Re: Rising Tide Towers, LLC - Telecommunication Facility Development Permit Application.

Subject: LUPC Data Request on pending Development Permit Application DP 5050-B, Dallas Plantation, Franklin County, Maine - dated 4/14/2021.

RISING TIDE TOWERS
RESPONSE TO LUPC 04/14/2021 DATA REQUEST

PROJECT NUMBER: RT-13
 SHEET NUMBER: C1.1

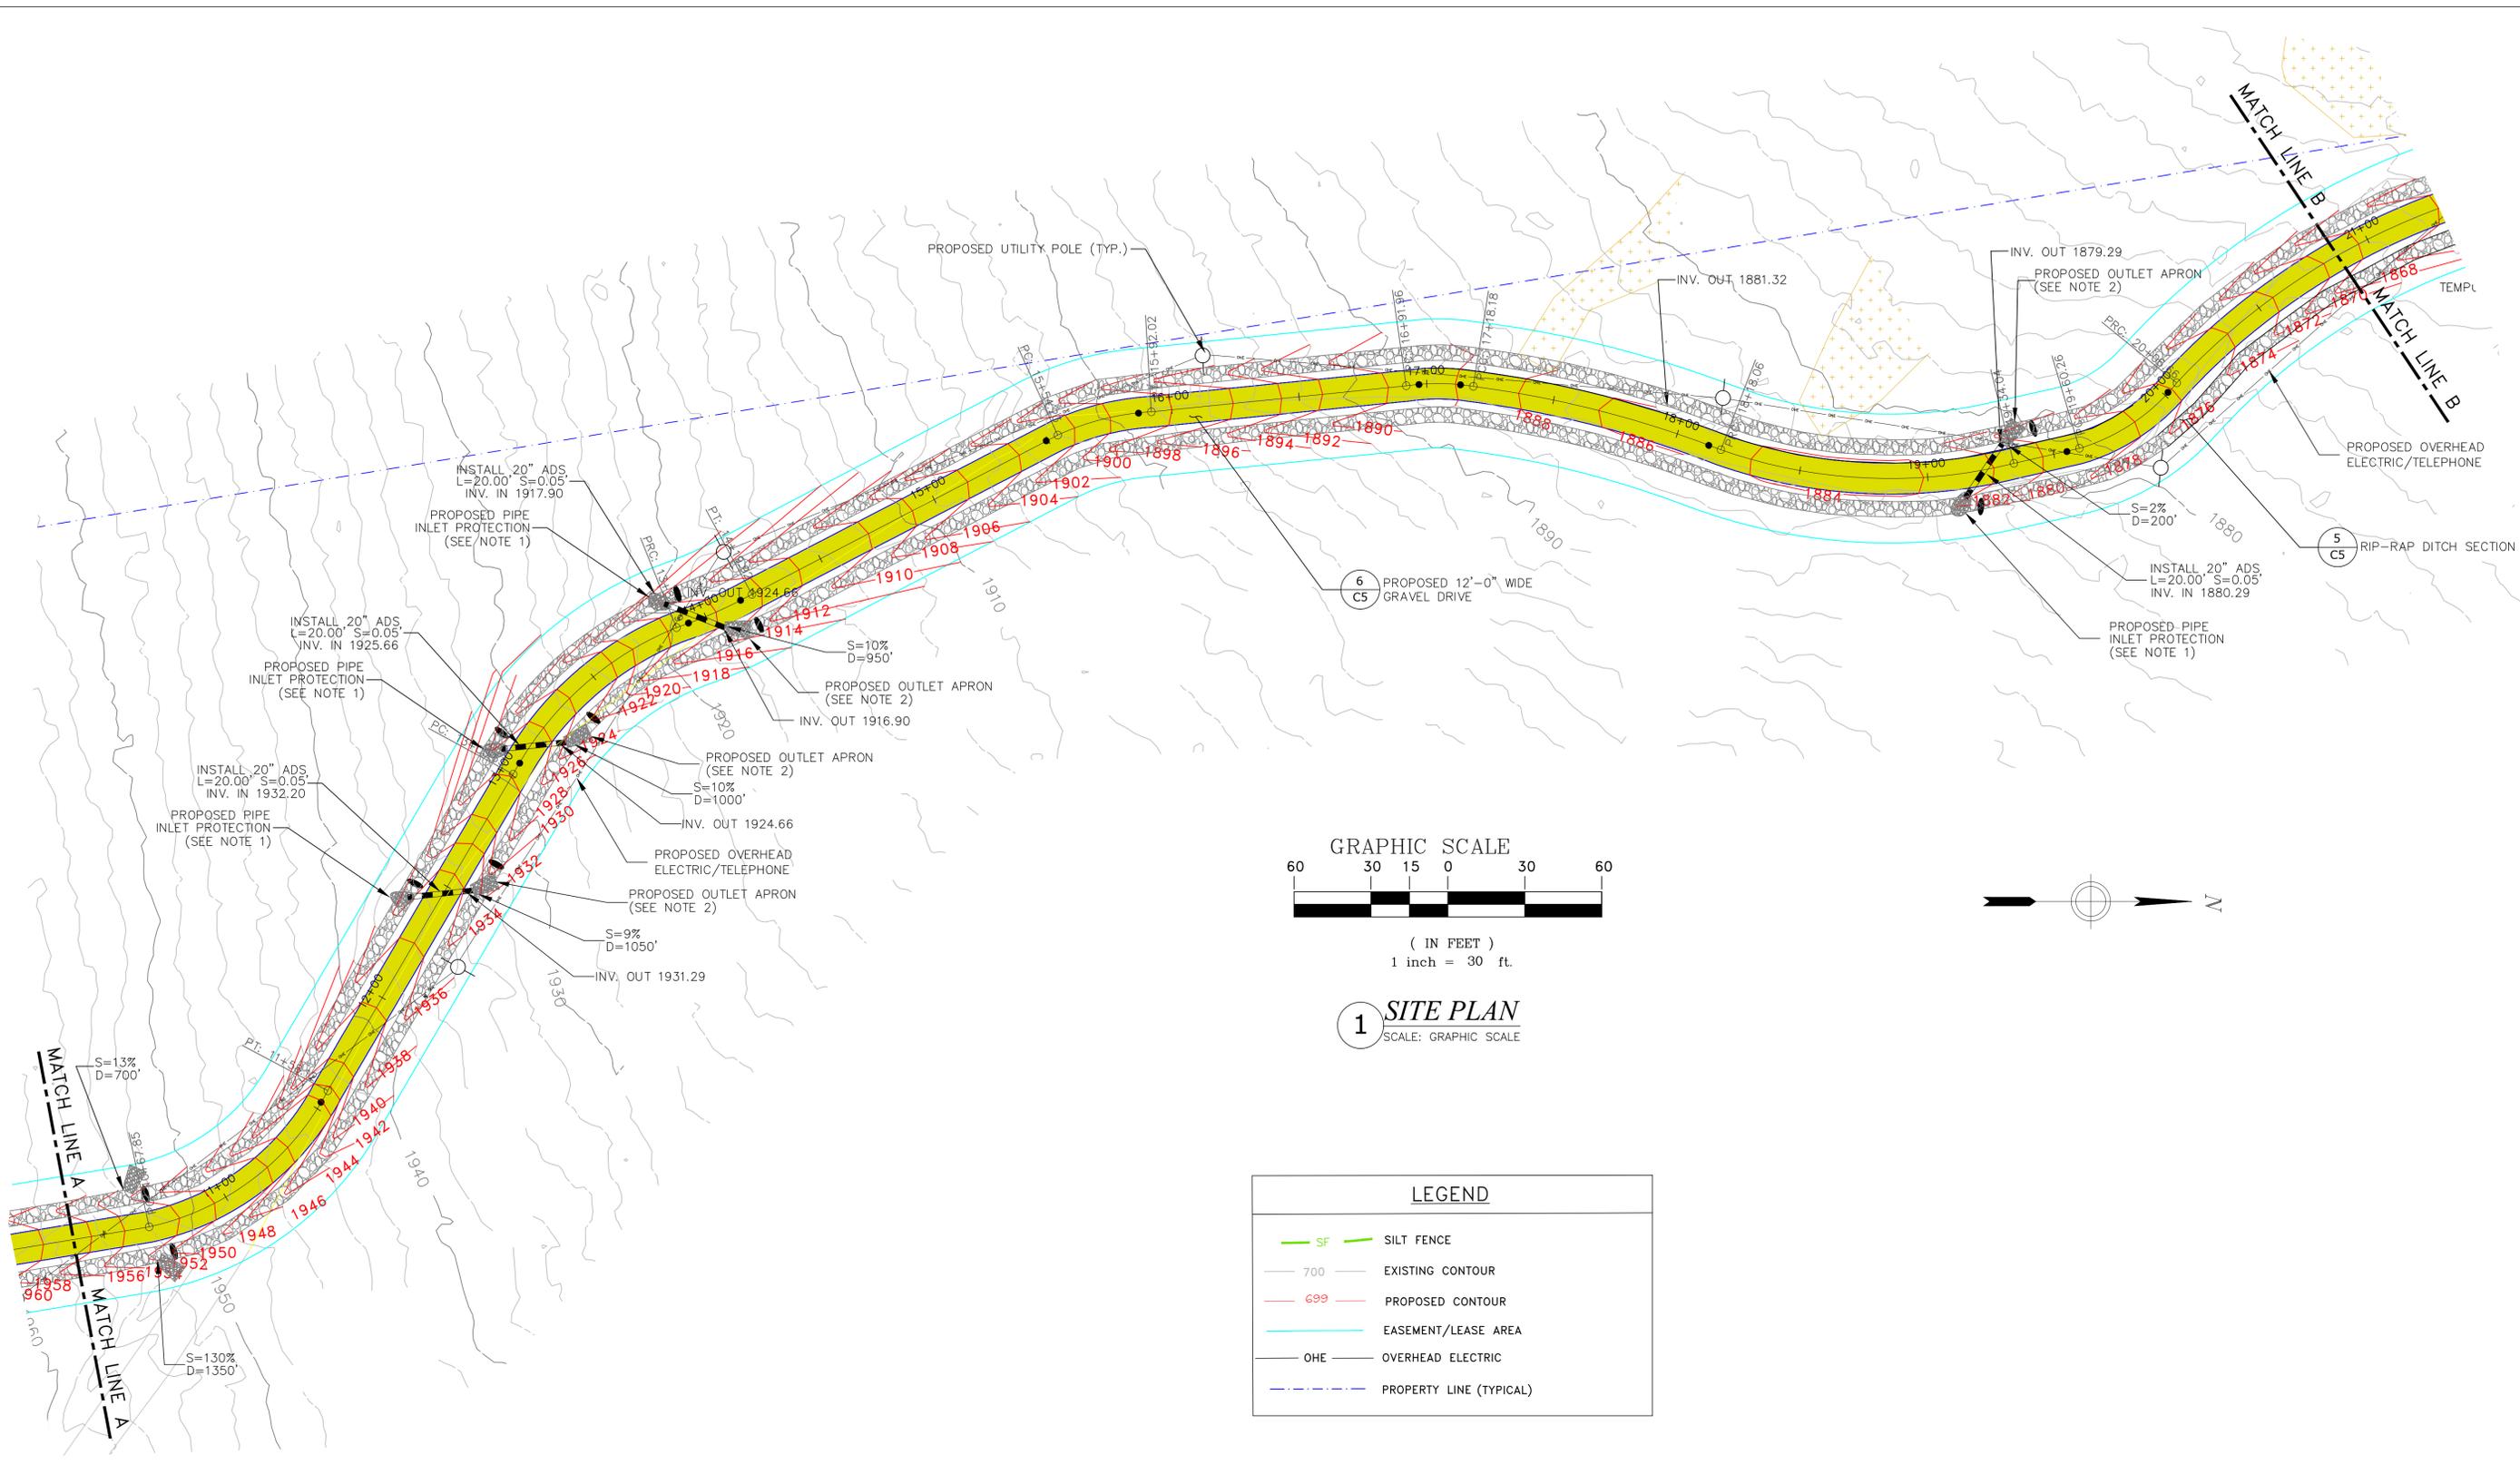
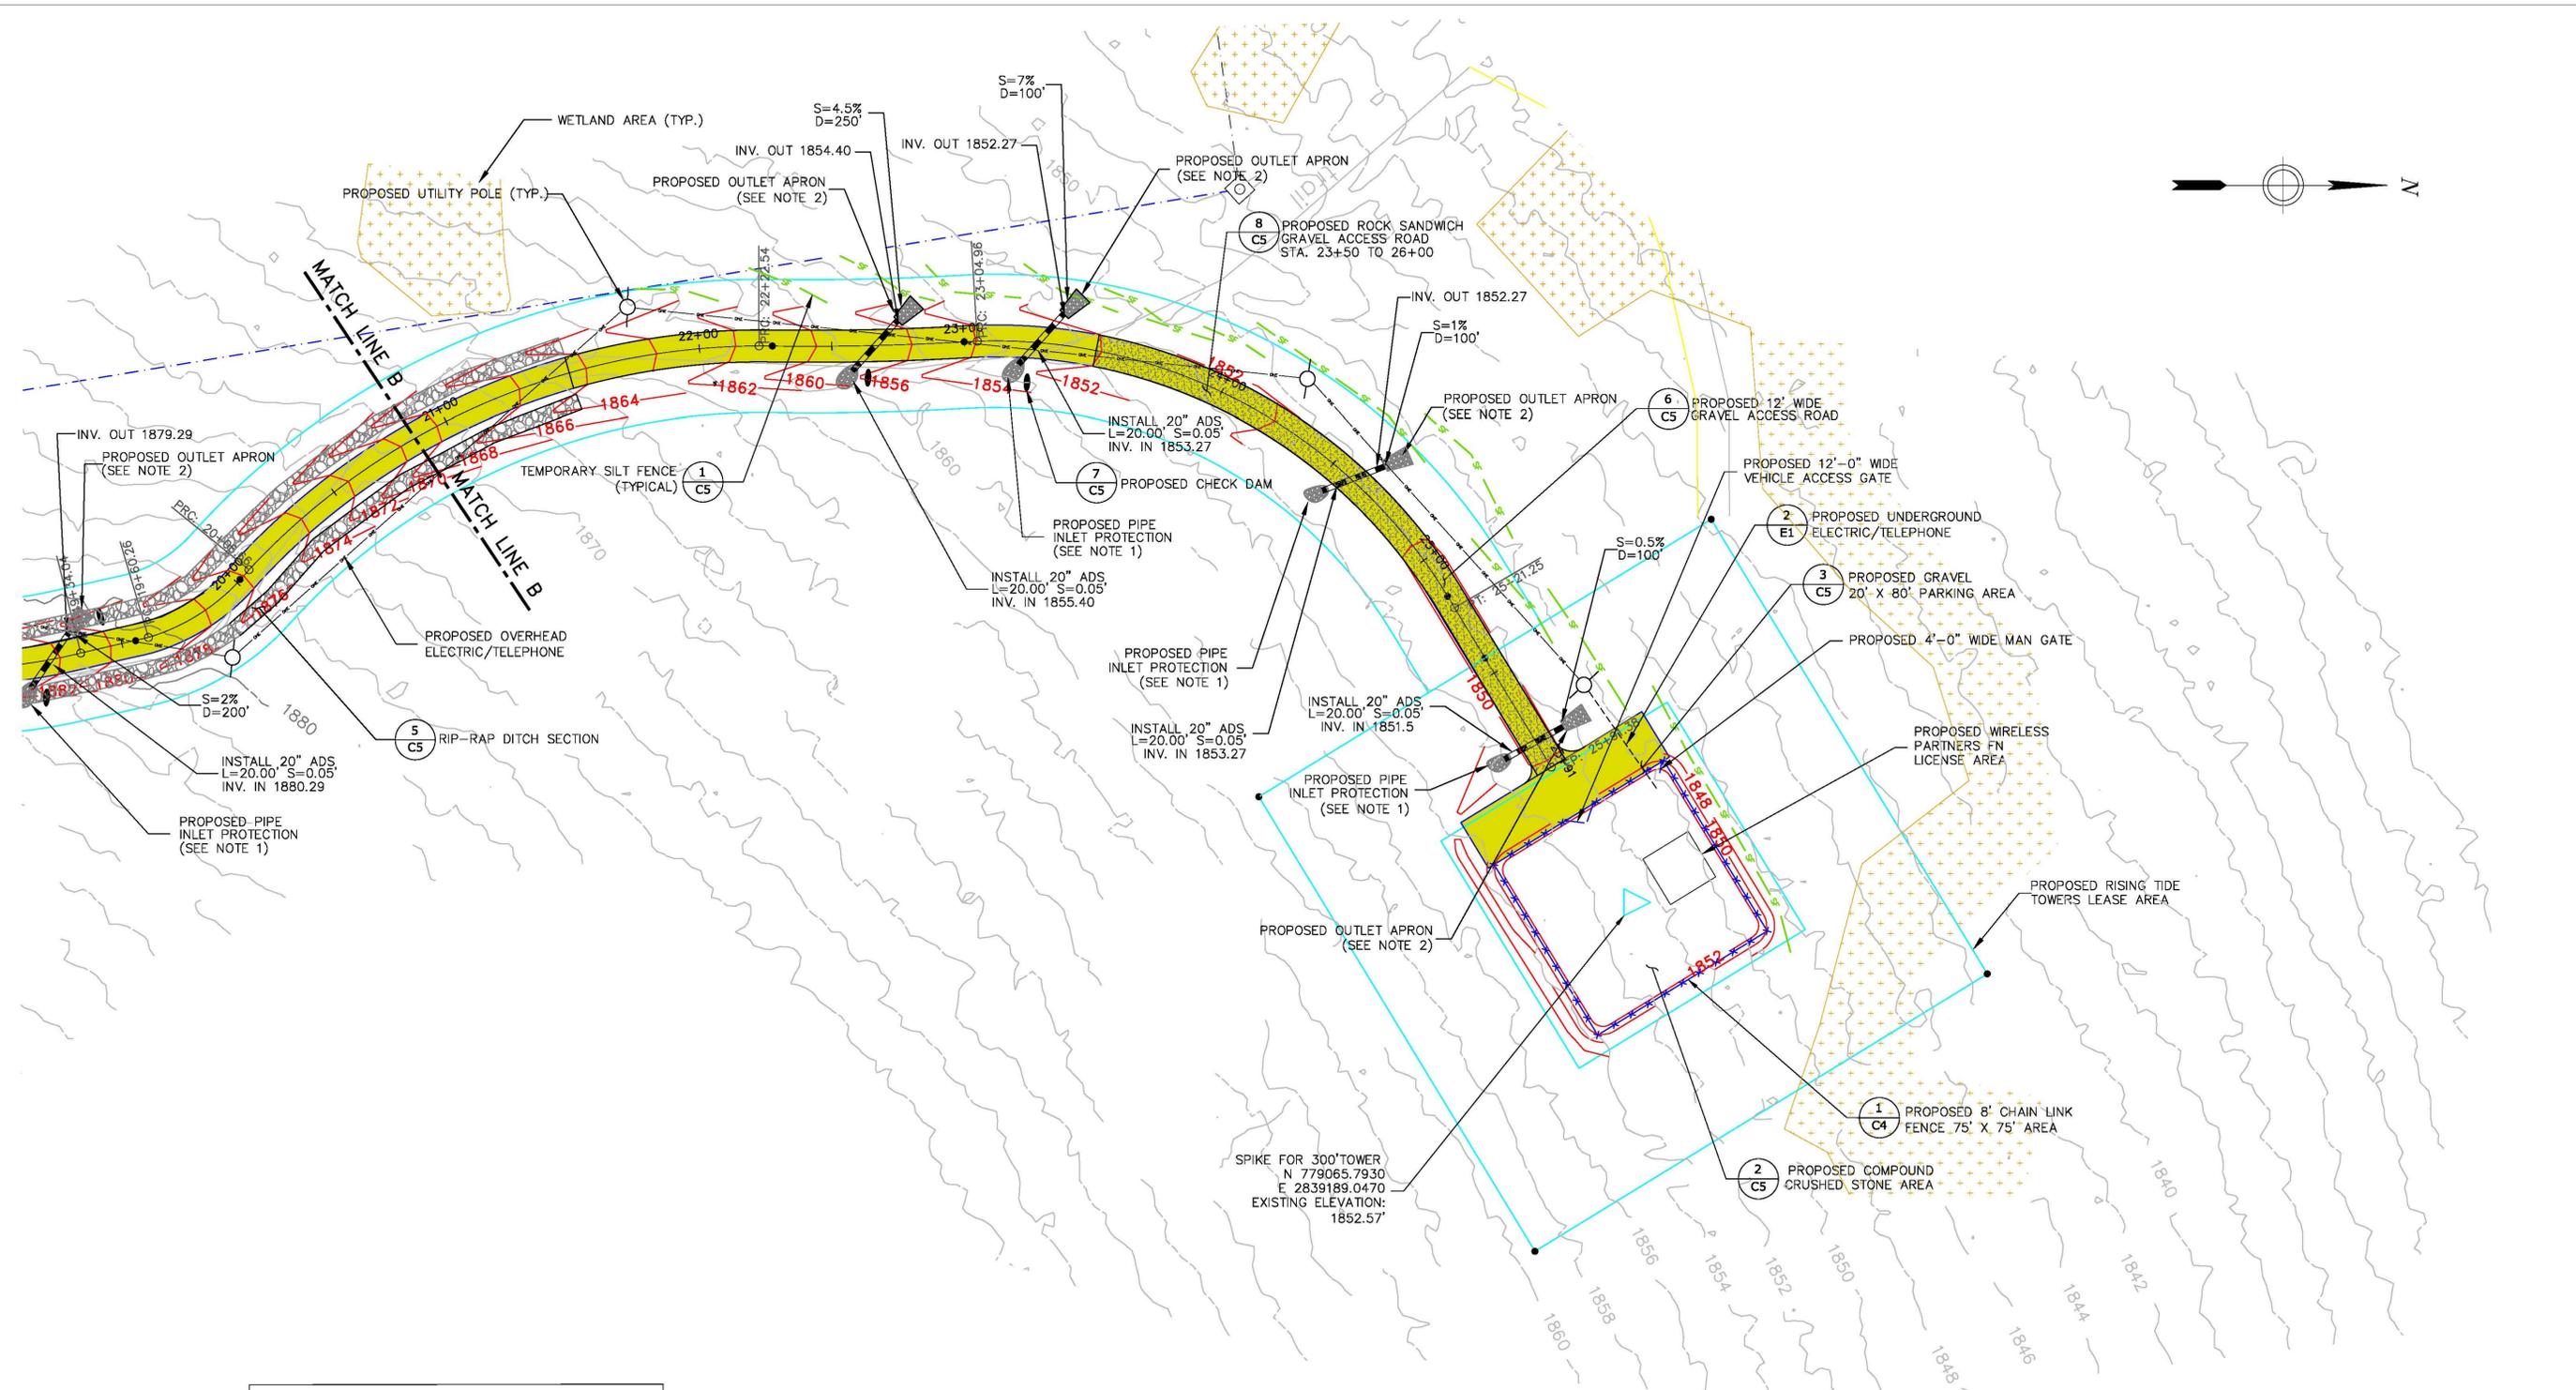
(D) Filter strips – Section 10.27,D,1,e provides that roads, drainage ditches, and turnouts must be located, constructed, and maintained to provide an undisturbed filter strip, of at least the width indicated in Table 10.27,D-1, between any exposed mineral soil and the upland edge of a wetland. The proposed access road, drainage ditches, and turnouts

have all been designed and configured to avoid exposing upland soil sedimentation transport to any P-WL1 wetland. Ditch turnouts are labeled on the site plan drawings, and the attached site drawings now identify the slope of the land at turnout locations as well as the distance to the upland edge of the nearest wetland or waterbody. The turnouts are located to provide undisturbed filter strip distances from access road turnout discharges to the upland edge of the nearest wetland or waterbody, in accordance with the requirements of Table 10.27,D-1.
